**Recall Campaign Launch Notification**

<b>Campaign No. :</b>	<b>NHTSA ID / CA DMV :</b>	<b>Campaign Desc. :</b>
2023070012	23V445	23P4790205

**Replace Fuel Pump Delivery Module – Wave 6**

Revision G: 09/03/2024

Figure 2

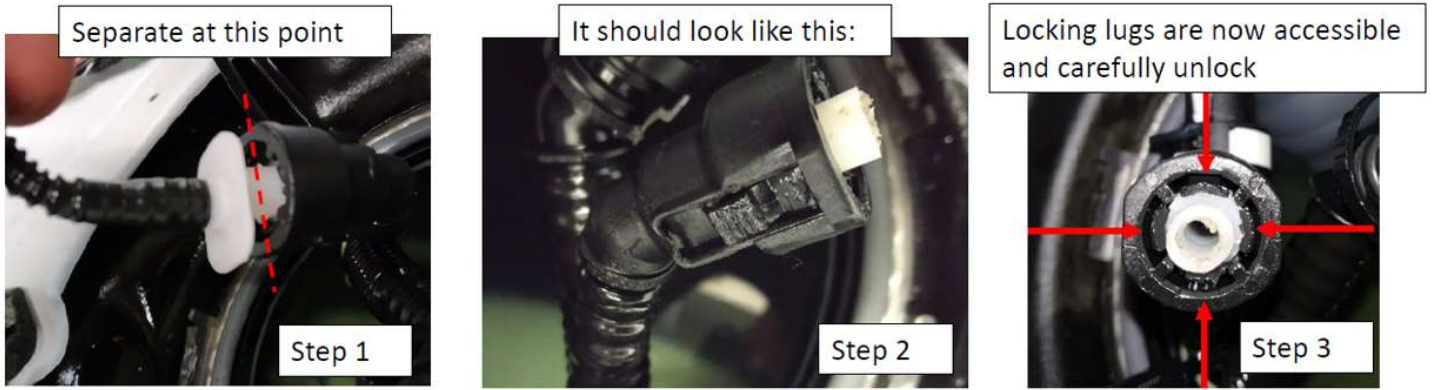
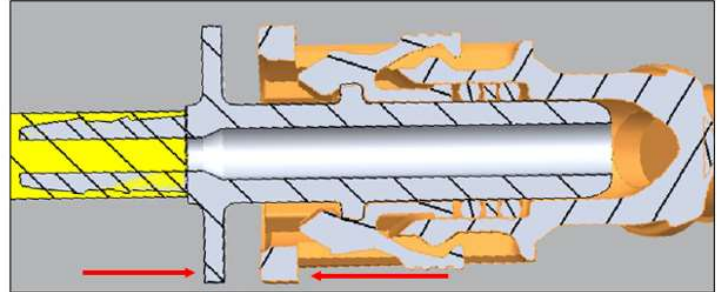
**i** Only model 206, 232: Note on disassembly of suction jet pump drive line quick connector. The procedure step 1-3 should only be performed when the quick disconnect is not working (Figure 2).

Squeeze the QC connection by at least 1mm, then unlock the latching lugs. If this is not possible. Step 1 -3

**Figure 3** (release corresponding connector and disconnect the contacts)

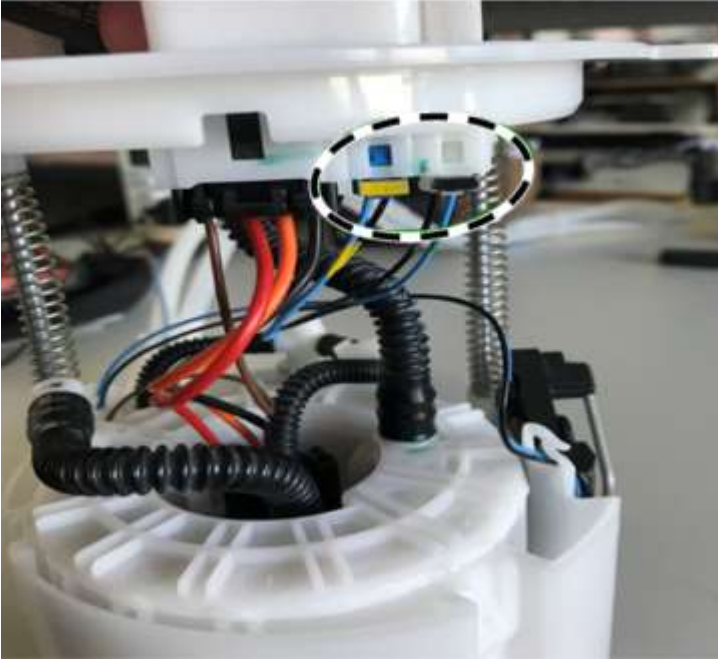
**i** Delivery modules that are delivered **without float-and-lever sensor** must be modified. (Figures 3-5)

**Figure 4** (remove lines from routing clip)

**Figure 5** (using a screwdriver, carefully push float-and-lever sensor housing away from module housing and at the same time push float-and-lever sensor housing upwards.)
